PARTS & SERVICE NEWS

REF NO.	AA03030
DATE	February 10, 2003

SUBJECT: TRANSMISSION SHIFTER UPGRADE

PURPOSE: To inform the field of the graders new transmission shifter program.

Item	New Part	Description	Qty	Old Part
①	1439 905 H92	SHIFTER ASSY, TRANSMISSION.....	1	1439 905 H91

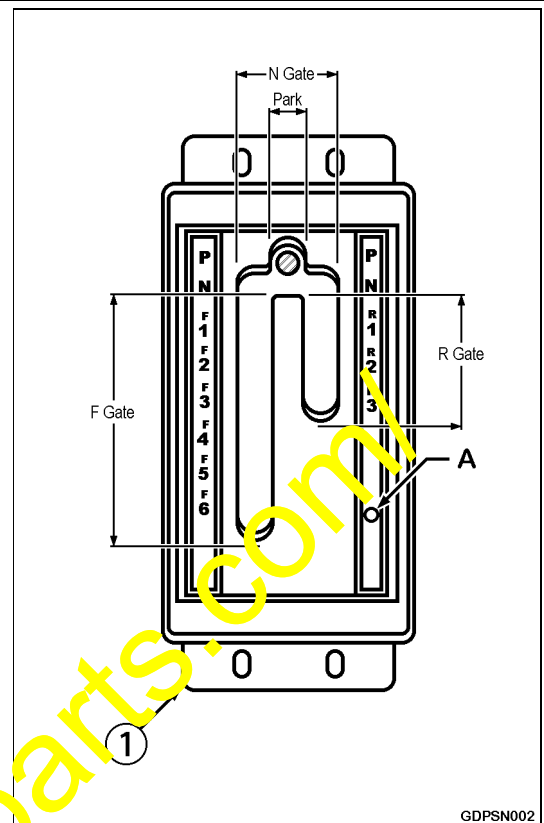
DESCRIPTION: The grader transmission shifter has been replaced for better shift response program, as some shifters were being returned for warranty when the shifter has not failed. With the previous shifter, operators complained not being able to make a fast shift out of neutral. In addition they did not like the programming when they landed in between gears, the shifter forced them to go back to neutral. The new shifter program permits a fast shift out of neutral. The program was also such that the if the shift handle stops in between the detented handle positions the grader remains in the last gear for 0.25 second then drops to neutral. The handle can be moved to the desired gear without having to return to neutral.

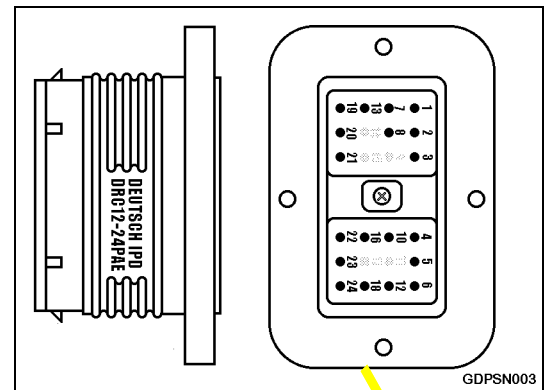
The U gate shifter now has on board diagnostics. A red colored LED (A) on the right side of the shifter will flash a code to indicate the type of problem. See the following table to for a diagnostic interruption of the error code flashing sequences.
